Product Change Notice

PCN Ref N°: New “detents” design with improved feeling for 15mm series.

Visual: left: round detents (old) / right: rectangular-elongated detents (new)

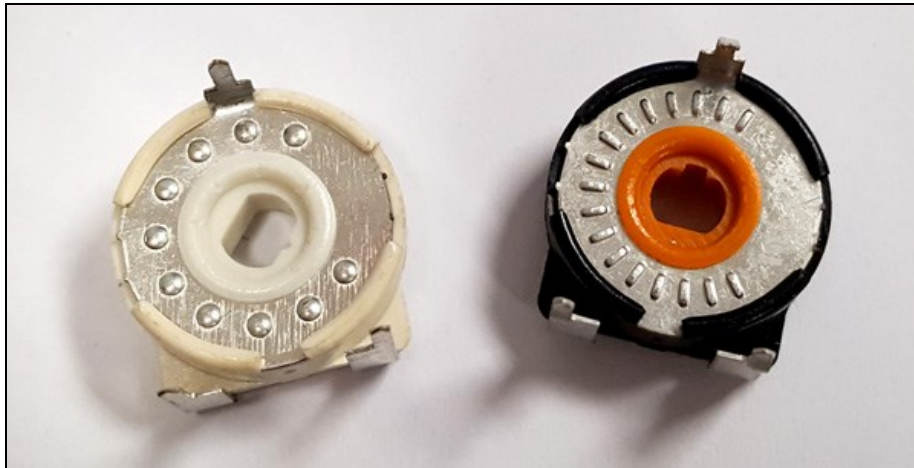
Please be advised that we are changing our detents feature from **round** to **rectangular (elongated)** shape.

[Reason for the change] The new shape affords a more sharp and homogeneous feeling without compromising any mechanical or electrical specification.
